Land Disturbance

Brian Williams

MoDOT Stormwater Compliance
Coordinator

Compliance Reviews

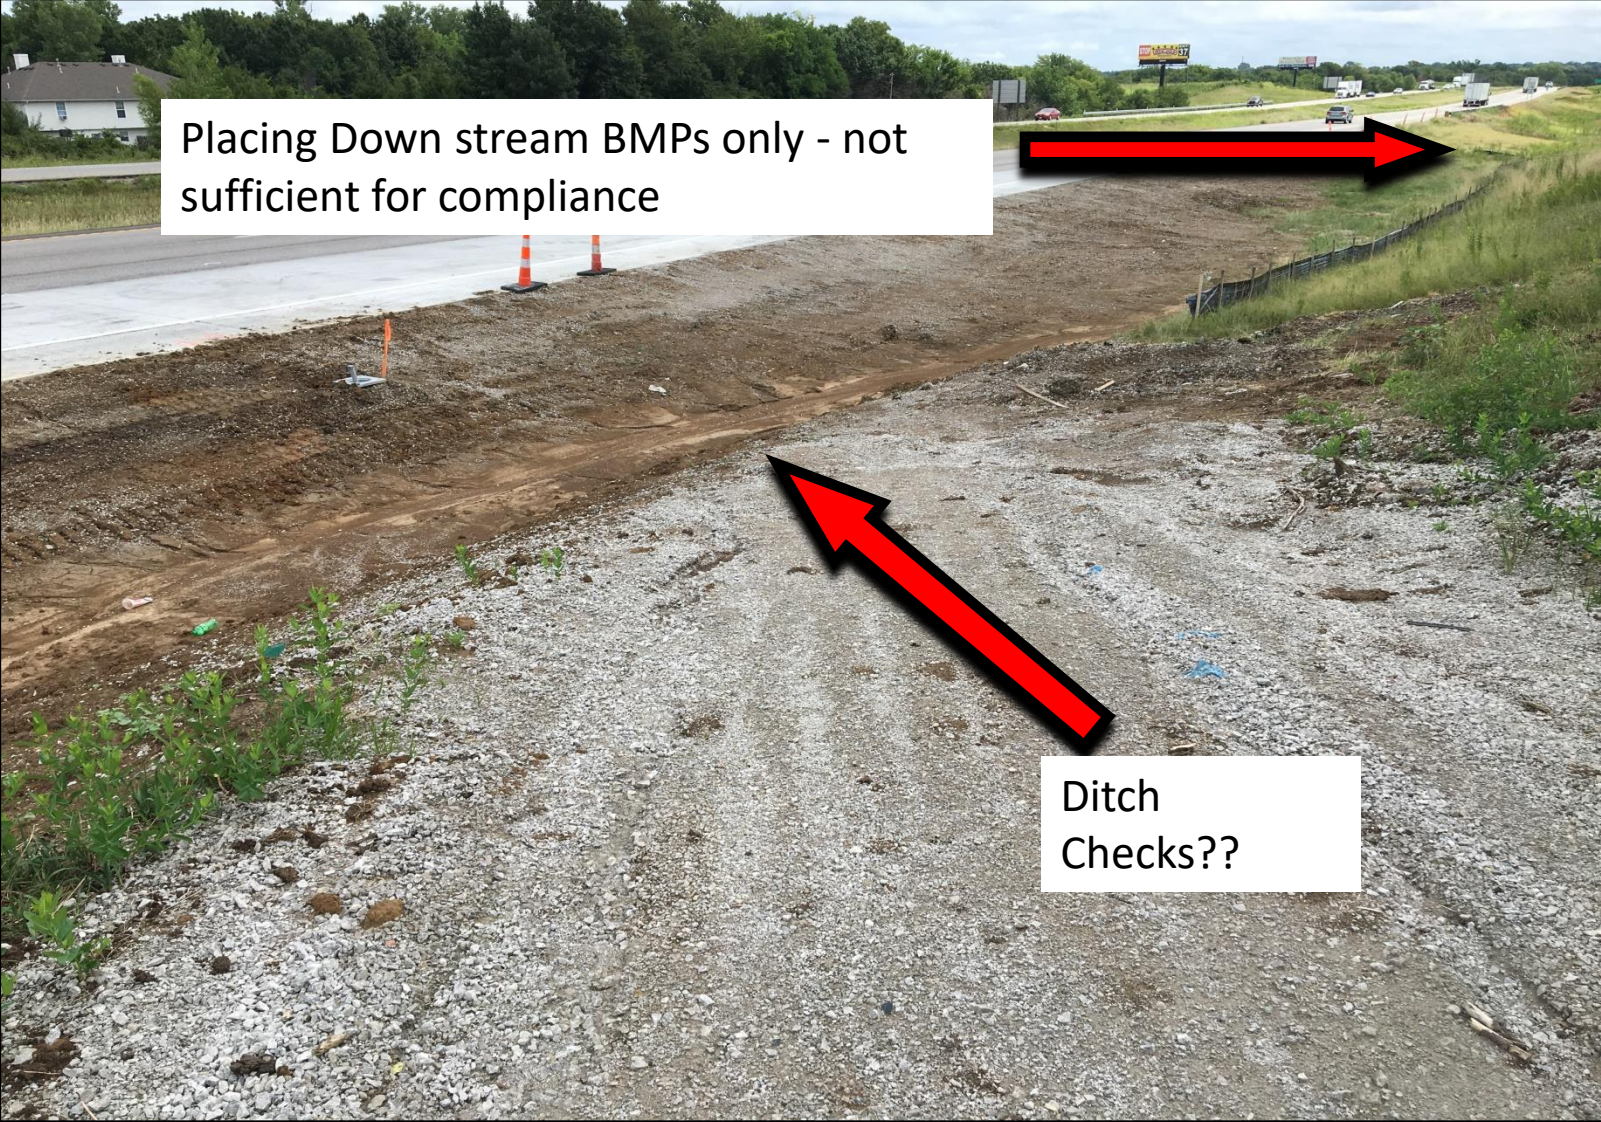
Unprotected slope

Silt Fence Undermining
